From: Bennett, Jim
To: ["Trey Driscoll"](#)
Cc: [Patrick BROWN](#); [Gungle, Ashley](#)
Subject: RE: Comments on GW Resources Allocation and Identification Plan
Date: Friday, July 19, 2013 8:41:00 AM
Attachments: [PDS2009-3300-09-008-PDS-PLN-Specialist Comments-Groundwater.pdf](#)

Memorandum

SUBJECT: Groundwater Supply Options; Project Number P09-008

Figure 1
JCSD#6: Drawdown

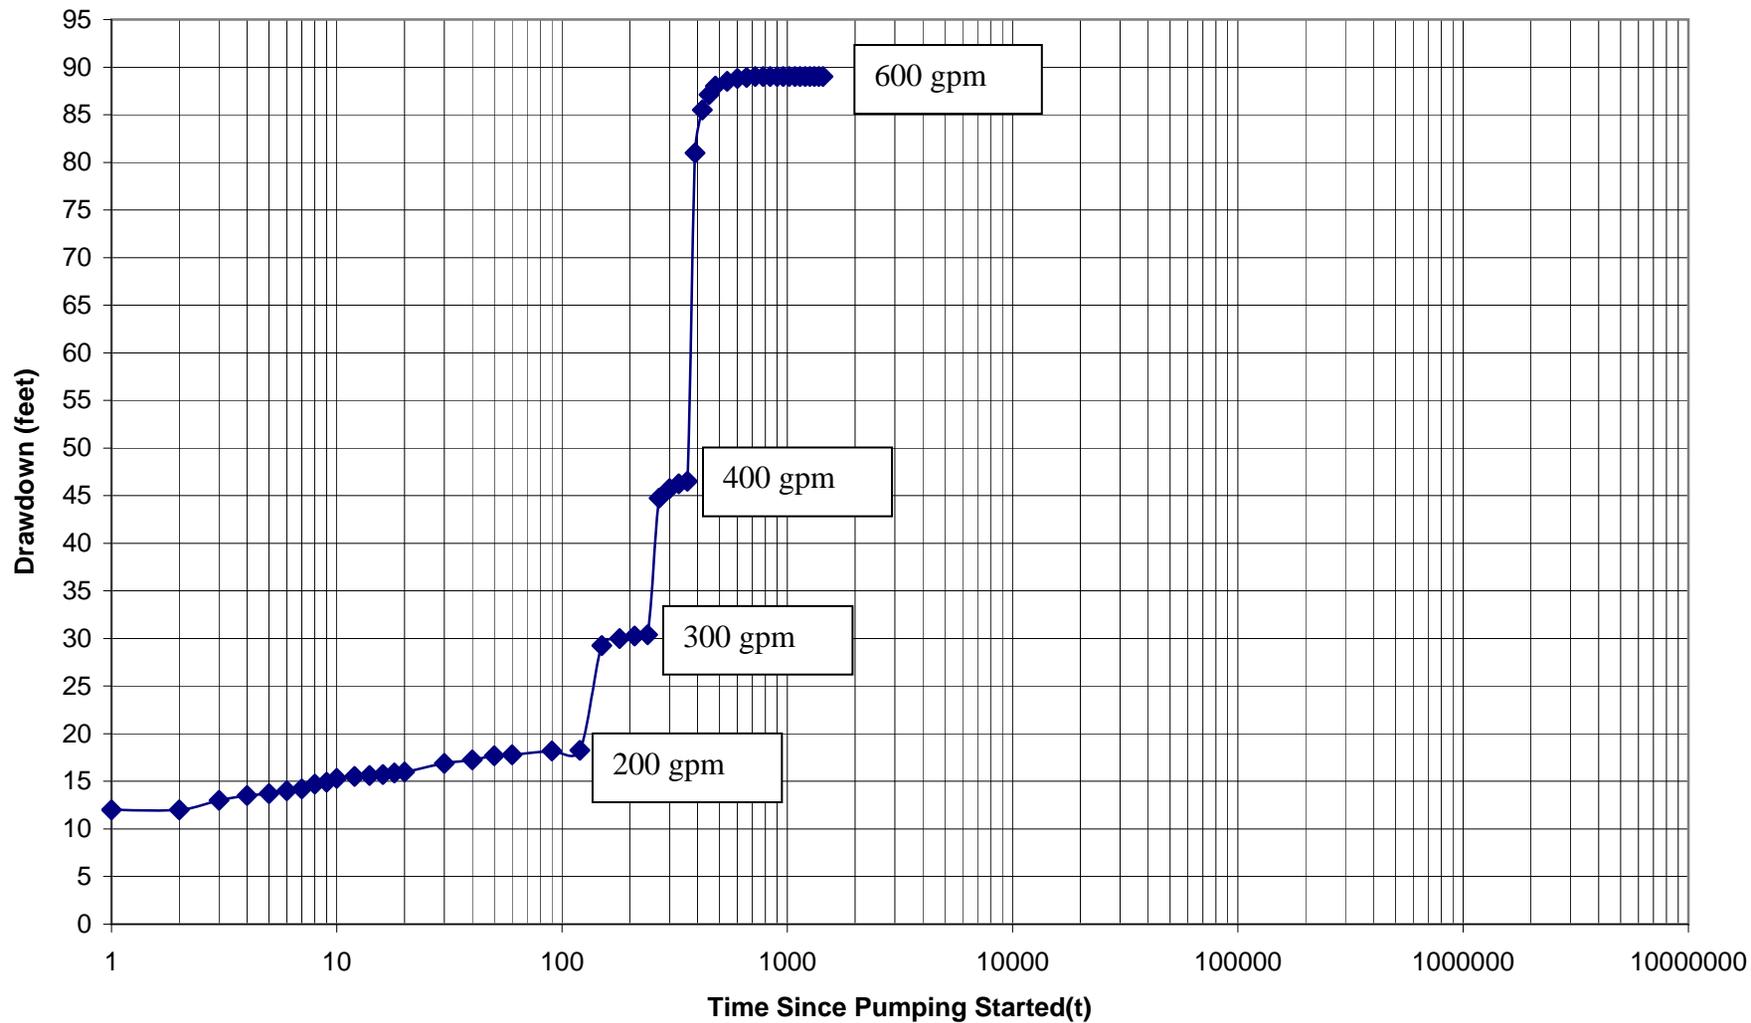
A 24 hour step-drawdown test was conducted by Fain Drilling on April 24, 2003 to obtain an approximate production rate for the well. Drawdown and recovery plots are provided as attached Figures 1 and 2 to this document. The well was pumped at 200 gallons per minute (gpm), and stepped up to 300, 400, and then 600 gallons per minute after six hours of pumping. At 12 hours, the water level reached 92 feet bgs and remained at that level until the end of the 24 hour well test. The water level after 5.6 hours of recovery fully recovered to 3 feet bgs. A total of approximately 759,000 gallons of water was pumped from the well in 24 hours. It is likely the entire 780,000 gallons of water the project needs could be produced from this well in 24 hours.

Figure 2
JCSD#6: Recovery

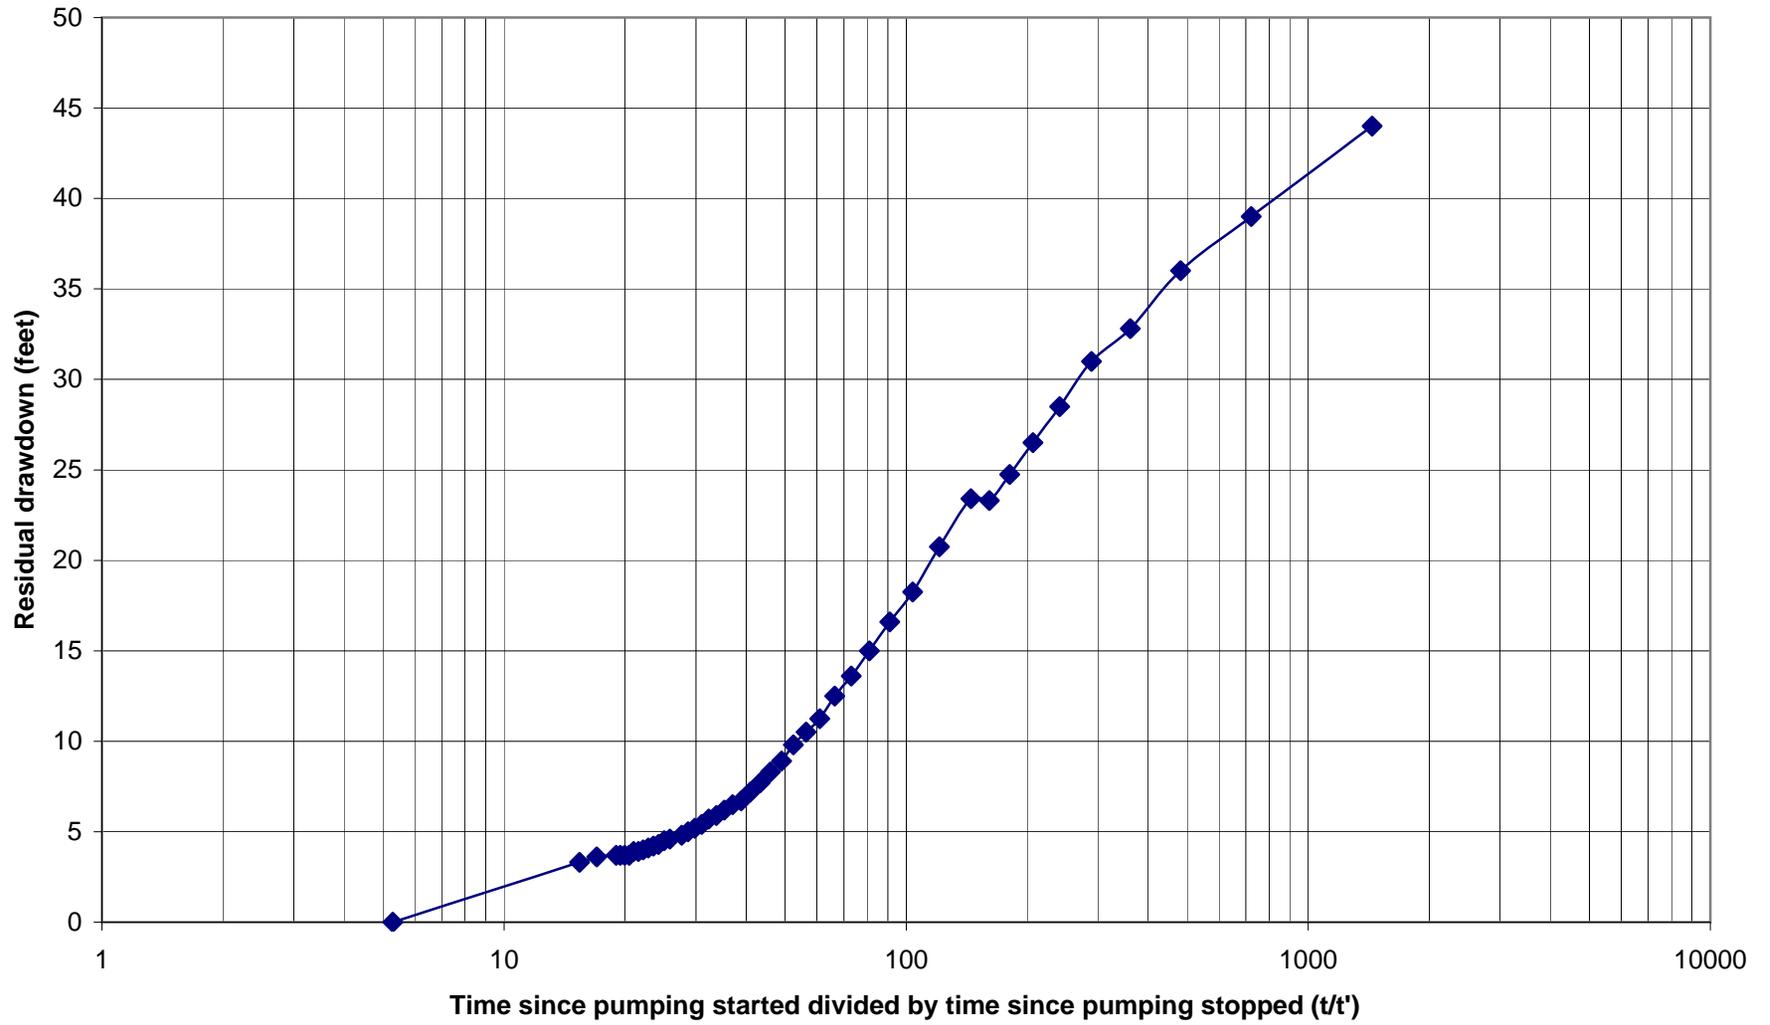
Aquifer transmissivity was first estimated using the Cooper-Jacobs approximation to the Theis equation as follows:

T =	809.8	Transmissivity (feet ² /day)
Q =	101,711	average pumping rate of 527 gpm (feet ³ /day [multiply gpm by 193])
π =	3.14	pi
Δs =	23	the change in residual drawdown over 1 logarithm of time (ft)
